STAFF REPORT

SUBJECT: Luna Hospice – AZ, CUP
[H-2024-0012](#)

Annexation (AZ) of 1.03 acres of land with an R-8 zoning district; and Conditional Use Permit (CUP) to operate a 14-bed hospice care facility.

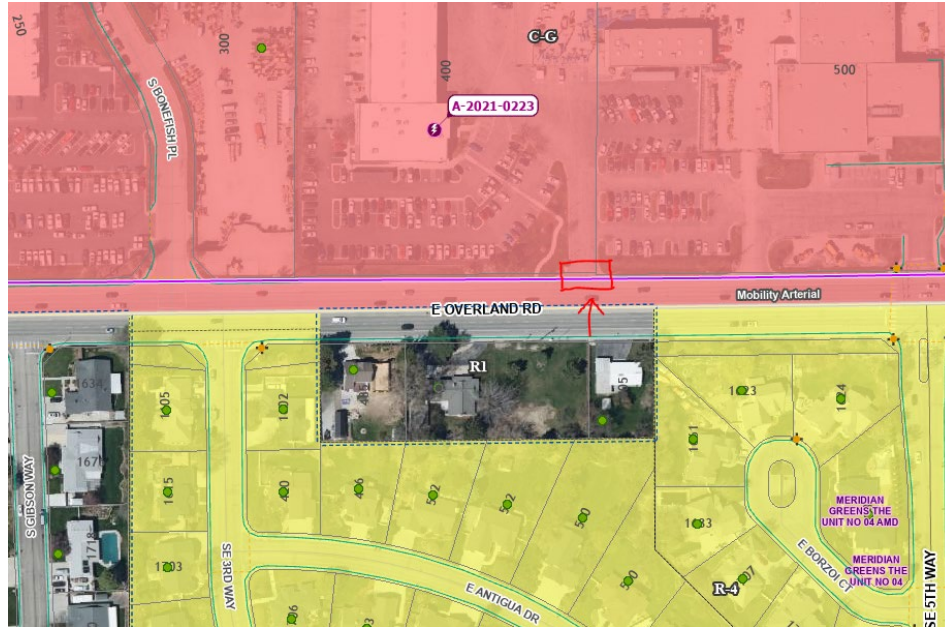
Access: Access is provided via E. Overland Road, an arterial street, via a fully improved “U” shaped driveway. Another existing 22-foot wide curb cut for a shared access drive onto Overland Road located at the site’s east property that aligns with the Western States Cat Equipment driveway on the north side of Overland Road (refer to below figure). ACHD provided the following Site-Specific Conditions of Approval below:

A. Site Specific Conditions of Approval

1. Repair or replace any damaged or deficient transportation facilities on Overland Road abutting the site, as determined by ACHD staff, and consistent with the current version of PROWAG.

2. Use one of the existing driveways located as follows:
 - A 46-foot wide shared access driveway located at the site's east property line (22-foot located onsite and 24-foot located on the adjacent parcel to the east).

- Or
- A 12-foot wide driveway located 270-feet east of 3rd Way (measured centerline-to-centerline).
3. Reconstruct the driveway chosen to be used (location listed above Site Specific #2) as a curb return type driveway with a maximum width of 30-feet and provide an on-site turnaround to prevent backing onto Overland Road. If the applicant chooses to use the driveway located at the site's east property line, then the applicant shall not modify the portion of the driveway that exists offsite on the parcel to the east. This driveway is approved as a temporary full access and may be restricted with a median at any time as determined by ACHD.

4. Close the existing 40-foot wide driveway located 375-feet east of 3rd Way with vertical curb, gutter and 7-foot wide attached concrete sidewalk to tie into the existing improvements on either side.

5. Close either the 22-foot wide portion of the shared access driveway located at the site's east property line (the applicant shall not modify the portion of the driveway that exists offsite on the parcel to the east) or close the 12-foot wide driveway located 270-feet east of 3rd Way with vertical curb, gutter and 7-foot wide attached concrete sidewalk to tie into the existing improvements on either side.

6. It is recommended that City of Meridian require the applicant to grant cross access to the parcel(s) to the east (S1119212501) and/or the west (S1119212410).

7. Other than the access specifically approved with this application, direct lot access is prohibited to Overland Road.

A. Annexation & Zoning Legal Description and Exhibit Map

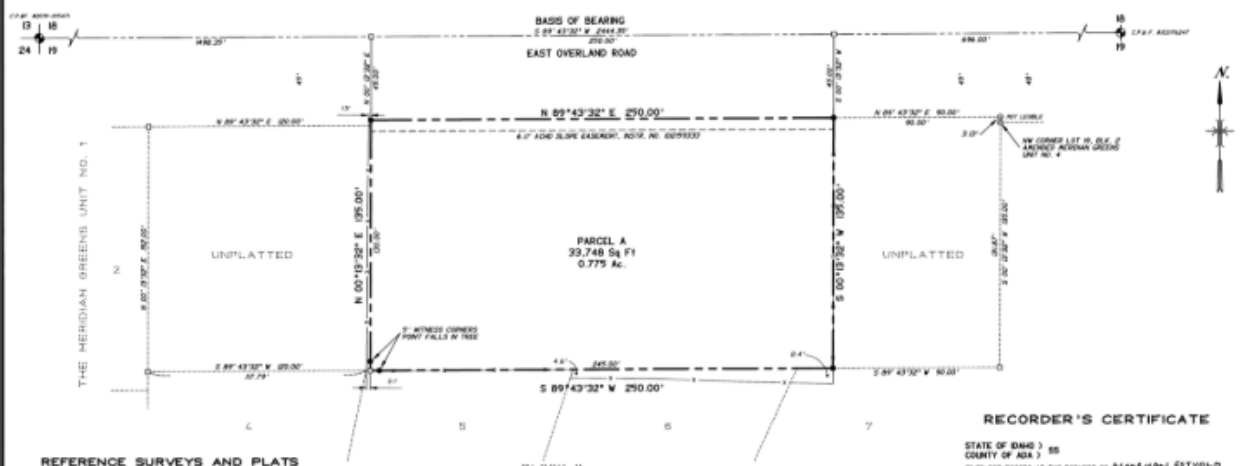
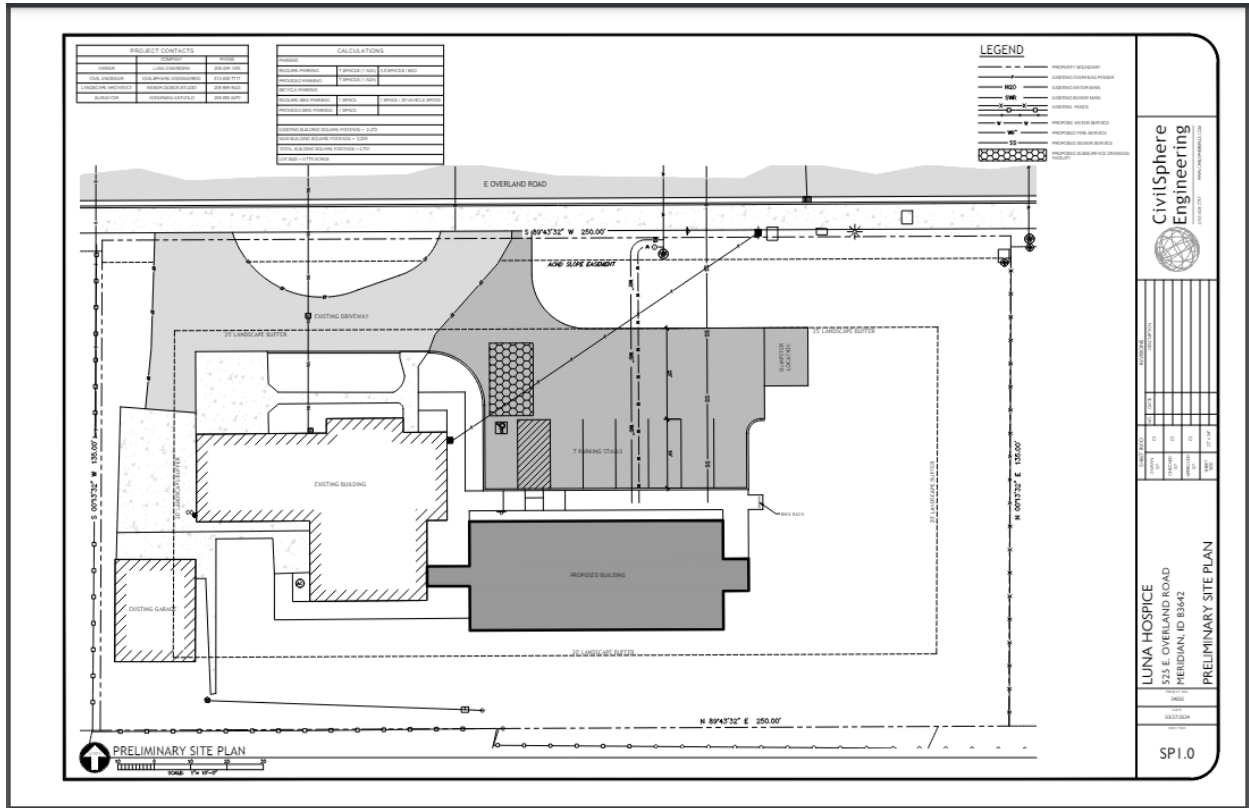
The site is within the Area of City Impact (AOIC) boundary and is contiguous to City annexed land to the north and south. A legal description was submitted for the boundary of the annexation area, included in Section VIII.A below. **However, the annexation exhibit map does not represent the correct acreage of the annexation boundary, and one of these exhibits identify the annexation area. Staff recommends that the Applicant provide a revised exhibit map fifteen (15) days prior to the City Council hearing that accurately represents the acreage of the annexation boundary, not just the property acreage.**

Revise the Exhibit map in Section VIII., Exhibit A to accurately represent the acreage of the annexation boundary 15 days prior to City Council Hearing.
